Ambrough Slough

HREP Boundaries Proposed

HREP Boundaries Existing

Cold Springs

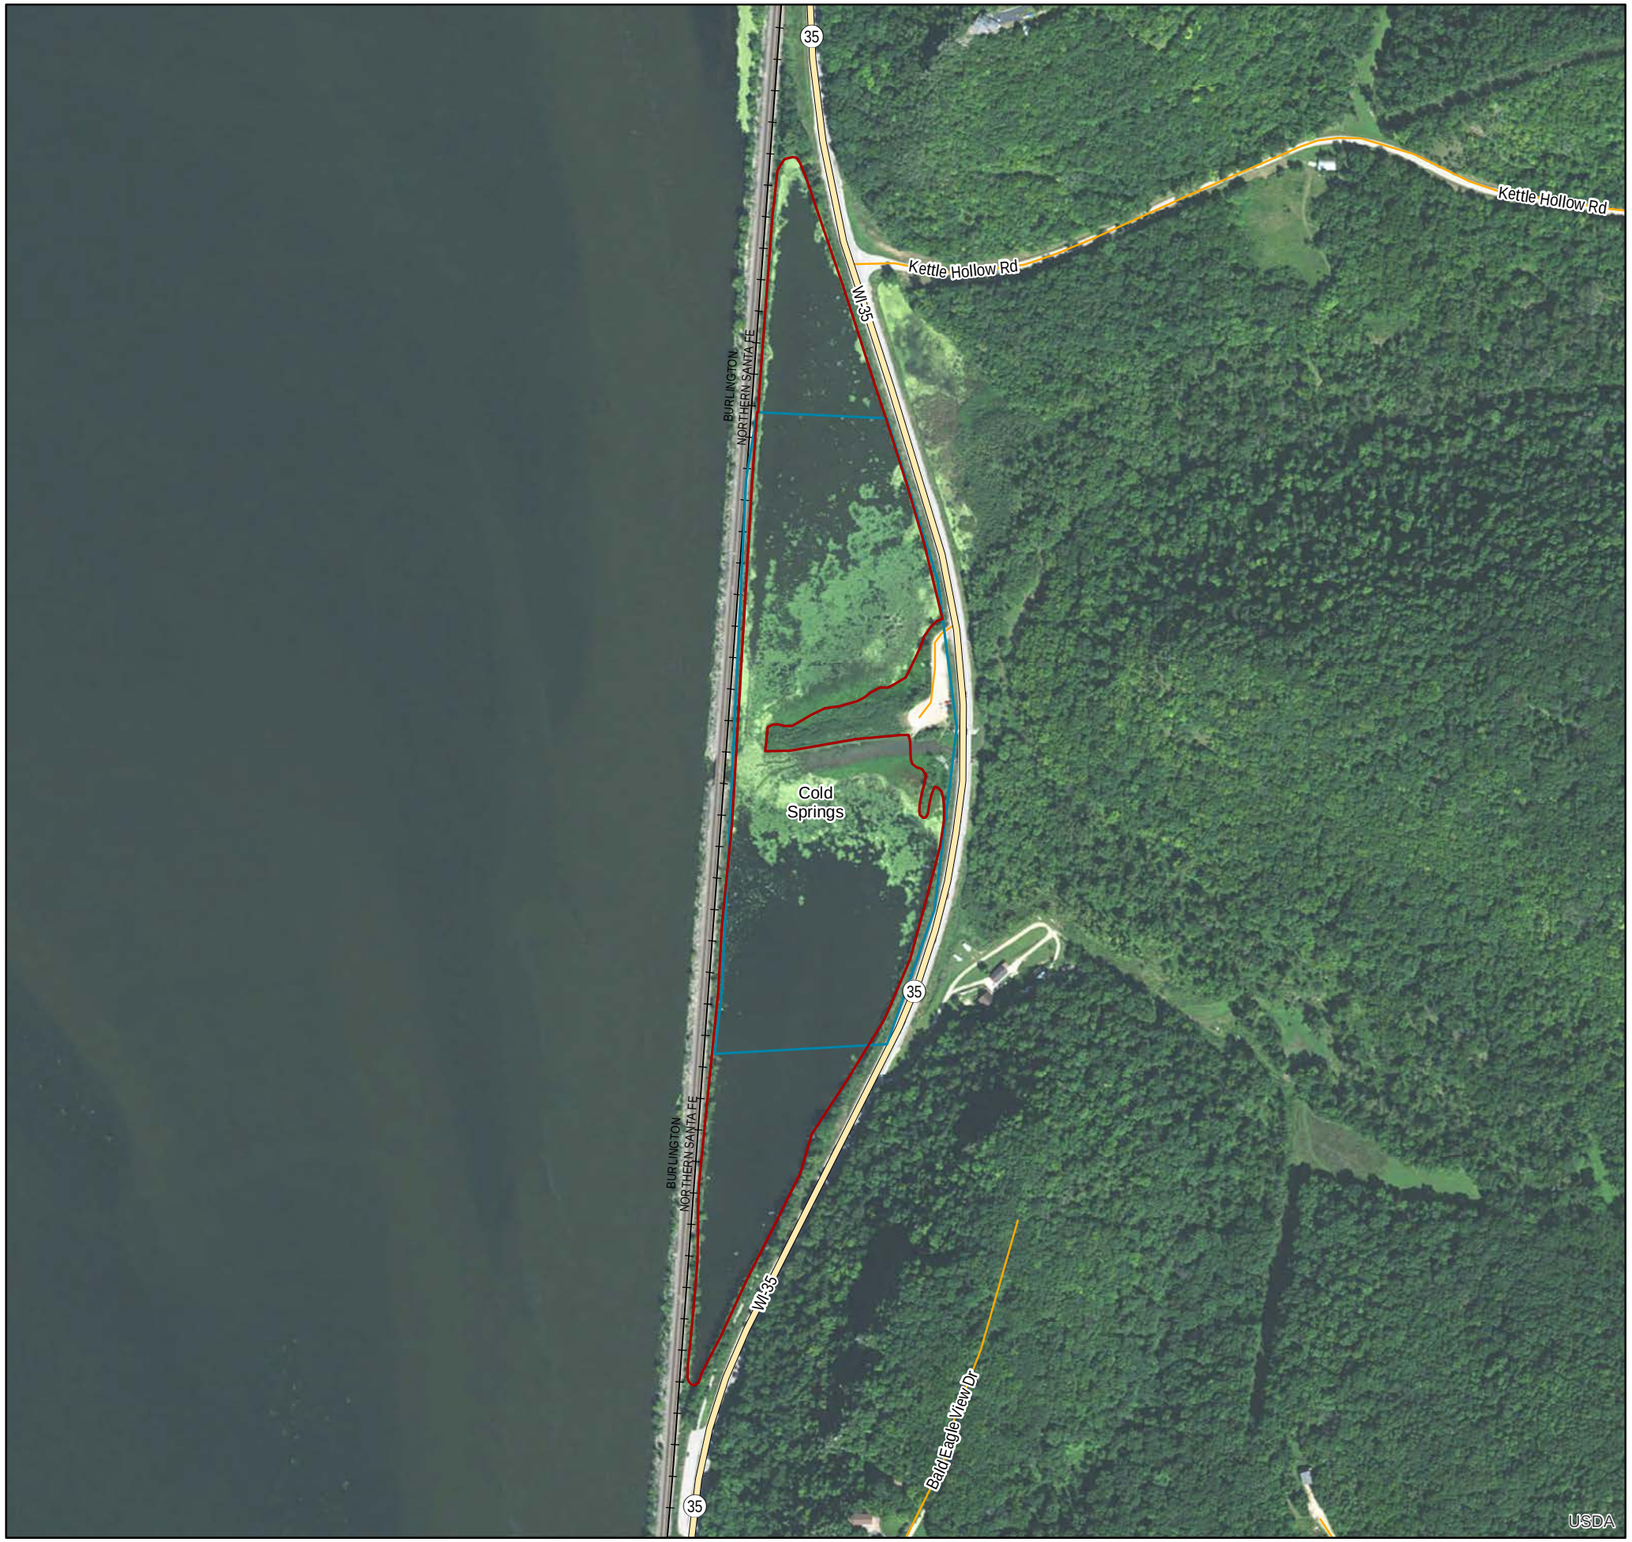
1. The north and southern boundaries should extend to include the entire north and south lobes.

1. The north and southern boundaries should extend to include the entire north and south lobes.

2. The east border will generally follow the shoreline.

Alternatives examined in the DPR included features that would have direct effect on the entire north and south lobes. The study area should be limited to aquatic habitat because of the project goals and objectives.

Peterson Lake

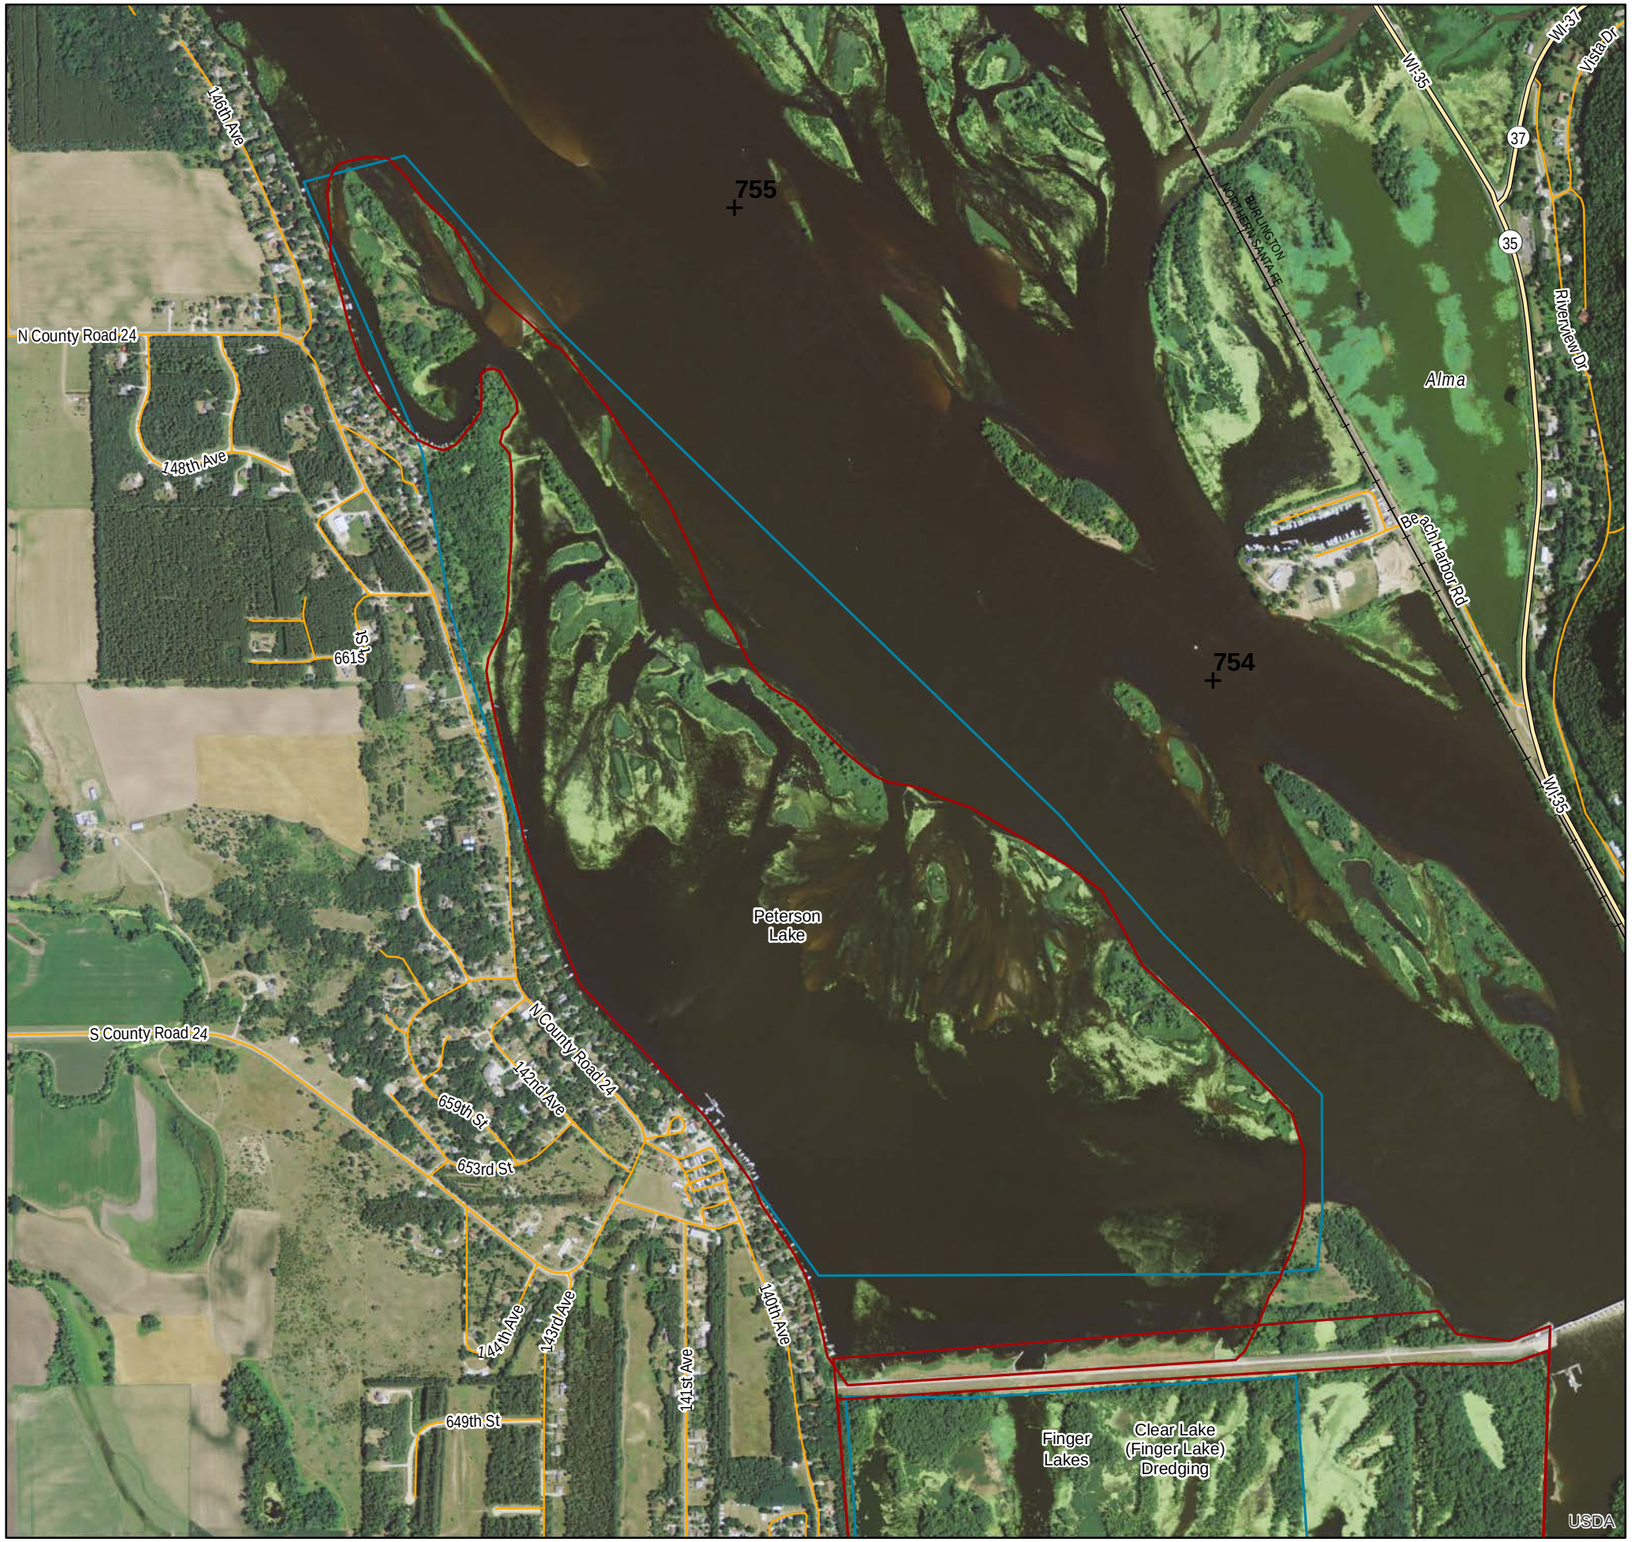
1. There is a discrepency between the current GIS boundary, the UMRRDB reported acreage, the Fact Sheet, the area analyzed for habitat benefits across alternatives in Feasibility, and the area reported in the Performance Evaluation Report.

1. Extend the southern border to meet the LD4 embankment.

2. Exclude areas that are uplands to a practical extent (southeast and northwest corners).

Project objectives are focussed on aquatic habitat. The closing structures would affect water quality in all of Peterson Lake, and should extend down to the LD4 embankment.
